MAR 12 1987

TO ALL LICENSEES OF OPERATING REACTORS, APPLICANTS FOR OPERATING LICENSES, AND
HOLDERS OF CONSTRUCTION PERMITS FOR BOILING WATER REACTORS (BWRs) WITH MARK I
CONTAINMENTS

SUBJECT: REQUEST FOR ADDITIONAL INFORMATION-ASSESSMENT OF LICENSEE MEASURES
TO MITIGATE AND/OR IDENTIFY POTENTIAL DEGRADATION OF MARK I DRYWELLS
(GENERIC LETTER 87-05)

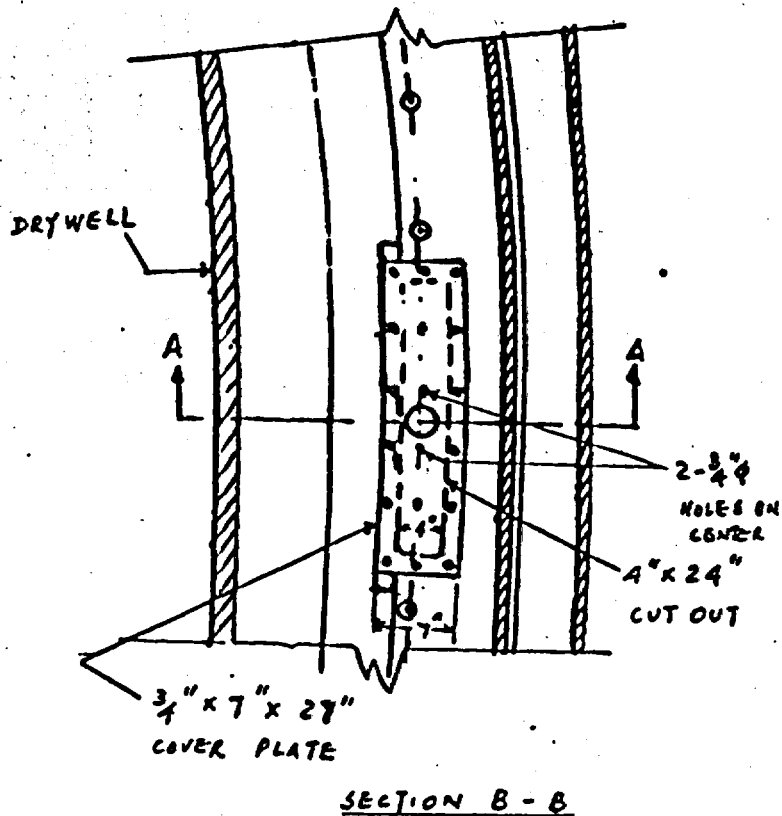
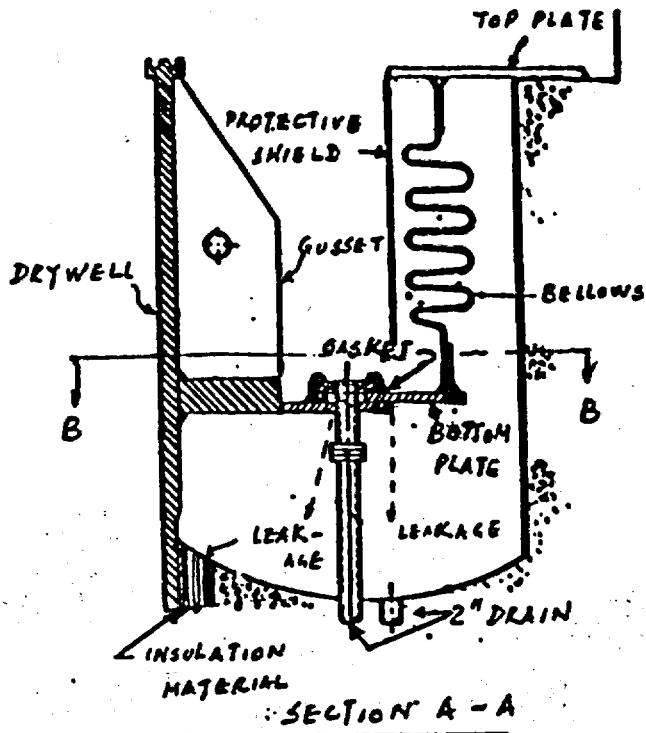
Upon reviewing the details of the sand cushion design at the various Mark I facilities, there appears to be a design feature that varies, dependent on the architect-engineer, that may be significant. In some designs, Figure 2, the sand cushion is covered with a galvanized steel plate which is sealed to the drywell shell and the surrounding concrete. Further, drains are provided to remove water which might collect on the plate from above. In other designs, Figure 3, the sand cushion is open to the gap between the drywell shell and the surrounding concrete and the only path for water to drain from the sand cushion is through the small drain lines at the bottom of the sand cushion. It appears from the Oyster Creek experience that, with the high permeability of the sand cushion and the small bottom drains, the likelihood of adequately drying the sand cushion is low if copious amounts of water have entered the sand cushion. The staff has sufficient concern to initiate the collection of information of the licensee's current or proposed action to assure the degradation of the drywell shell plates adjacent to the sand cushion has not occurred and to determine if augmented inspections above and beyond those planned by the licensee's are necessary.

Mark I Owners Whose Designs Are Such That The Sand Cushion Is Open To Gap Between The Drywell Shell And Surrounding Concrete

Provide any plans for performing ultrasonic thickness measurements of the drywell shell plates adjacent to the sand cushion or any other proposed actions to ascertain if plate degradation has occurred. Since the degradation that has occurred at Oyster Creek is localized, sufficient details should be included to show that the sampling basis for ultrasonic thickness measurements is adequate in terms of size and test location.

Figure 1

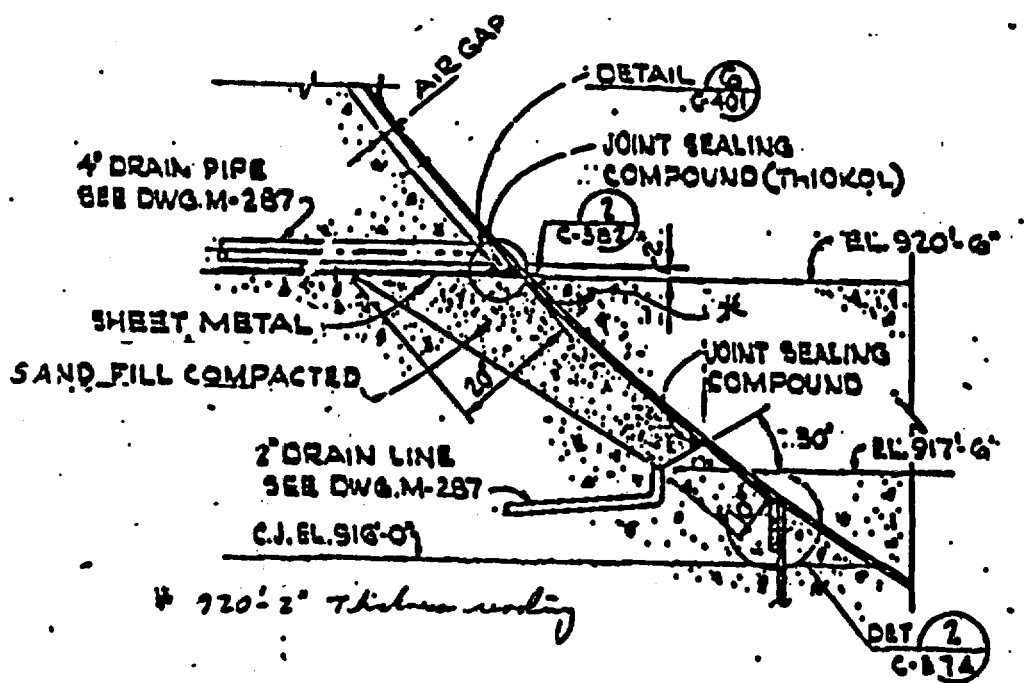
From the information obtained from the review of the Oyster Creek event, it appears one source of leakage that resulted in wetting the sand cushion was related to the deterioration of a drain line gasket at the drywell to cavity seal (see figure 1). There also is some question as to whether or not the drain line which serves to remove any leakage past the drywell to cavity seal was functioning properly.

- 1) Provide a discussion of your current program and any future plans for determining if the drain lines that were provided at your facility for removing any leakage that may result from refueling or from spillage of water into the gap between the drywell and the surrounding concrete or from the sand cushion itself are unplugged and functioning as designed.

- 2) Provide a discussion of preventive maintenance and inspection activities that are currently performed or are planned to minimize the possibility of leakage from the refueling cavity past the various seals and gaskets that might be present.
- 3) Confirm the information listed in Table 1 is correct with regard to your facility.
